## SERVICE BULLETIN

**NUMBER:** DCI-BH206L1L3L4-IBF-SB01  
**Date:** 12 July 2021

**SUBJECT:** BACKSHELL FASTENER REPLACEMENT

**Bell Helicopter - Model:** 206L-1, 206L-3, and 206L-4 (STC SR09421RC) (SN 0001 & SUBSQ)

**Figure 1 – Location of Backshell Screws Recommended for Replacement**

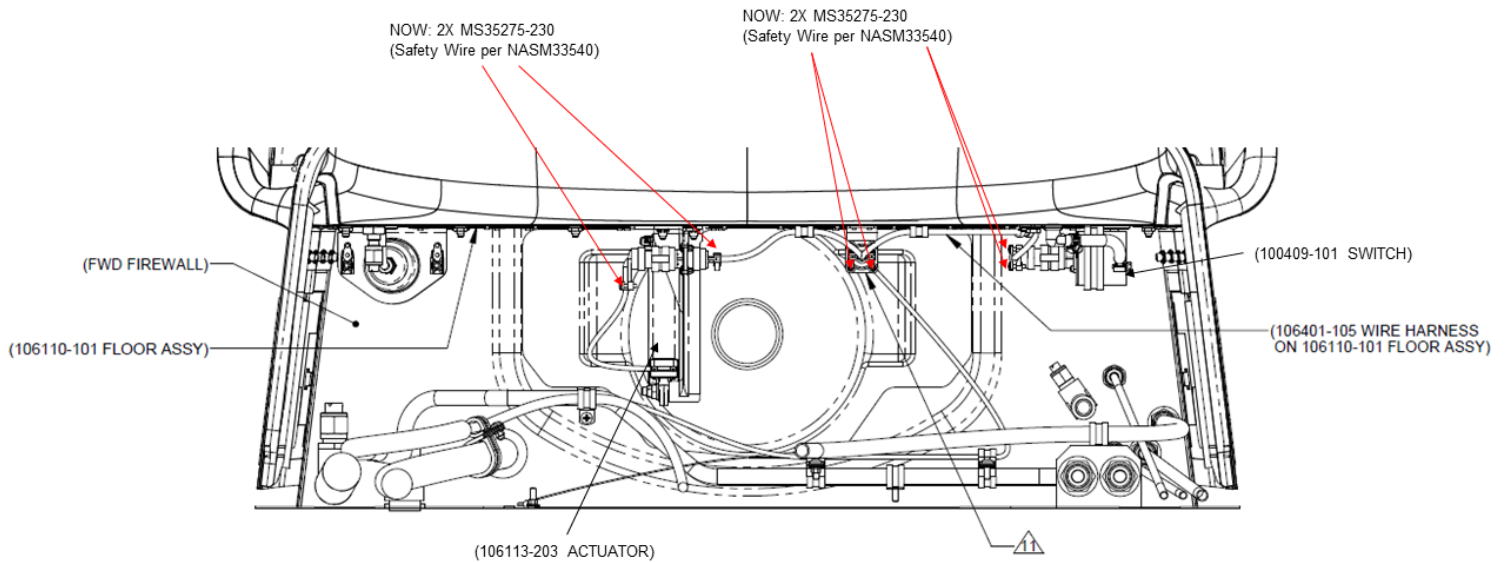
This is not a safety of flight issue, if operators follow Section 8.5.5 of the Instructions for Continued Airworthiness (ICA) and verify that Backshells are secure during regular maintenance intervals, then it is highly unlikely that the Backshell fasteners will come loose during flight. Nonetheless, Donaldson recommends a product improvement for all operators of the DCI Bell 206L-1, 206L-3, 206L-4 IBF by replacing the existing fasteners on the Backshell of the 106401-105 Wire Harness connecting to the linear actuator & the Backshell of the linear actuator (106113-203) with MS35275-230 screws and to safety wire the screws per NASM33540. Location of these screws can be found depicted in Figure 1. Inspection requirements for the Backshells will remain the same unless otherwise directed by a newer revision of the ICA (Reference 1).

Operators are recommended to locally procure the replacement hardware as applicable. If local procurement is not available, operators can procure the screws from Donaldson's ecommerce site found in the Contact section.
